METROPOLITAN DISTRICT
33712 Mountain View
Trinidad, CO 81082

October 1, 2020

COLORADO MANDATED CISTERN QUESTIONNAIRE

PROTECTING DRINKING WATER

1 MEET THE PLUMBING CODE

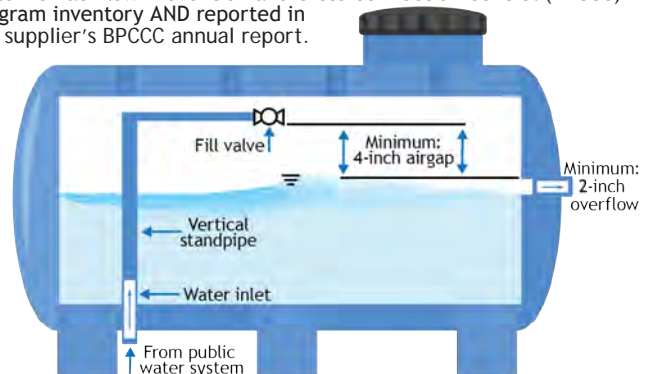
Potable water cisterns that meet the 2018 International Plumbing Code (IPC) requirements are controlled. No additional prevention or control measures are needed. Tanks with vertical standpipes with fill valves installed above the water line that have an appropriately sized overflow automatically meet the IPC.

INLET PIPE

- Controlled by a fill valve or other automatic supply valve
- Ends with an air gap at least 4 inches above the overflow as shown in the figure below.

OVERFLOW PIPE

- Minimum 2 inches in diameter. (Actual size is calculated by maximum capacity of water supply line to tank)
- Covered with a corrosion-resistant screen not less than 16x20 mesh per inch and 1/4-inch hardware cloth OR ends in a horizontal angle seat check valve.
